AP1000DCDFileNPEm Resource

Subject: New Fuel Rack RAIs - per Non-credible "drop" position
Sent Date: 6/29/2010 1:31:08 AM
Received Date: 6/29/2010 1:31:19 AM
From: Altmayer, Scott A

Response to Request For Additional Information (RAI)

RAI Response Number: OI-SRP9.1.4-SBPA-03
Revision: 32A

~~Figure 2-10 Baseplate Deformation Resulting from Fuel Assembly Drop onto Baseplate (2.41 inch Maximum Displacement Directly under Impact Location) (Removed by Revision 2B)~~

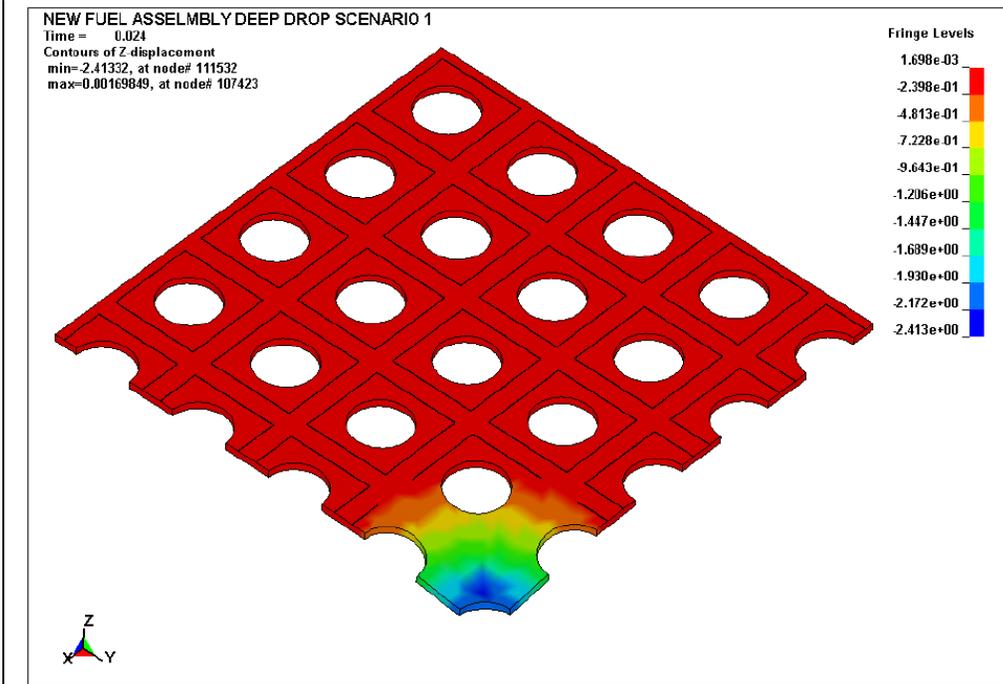
The figure change below ~~form from~~ Revision 1 is obsolete. The next revision of TR44 will remove all detailed discussions, tables, and figures that reference applicability of the new fuel assembly pit drop accident scenarios.

~~Yes~~ Figure 2-10 was replaced by the following figure:
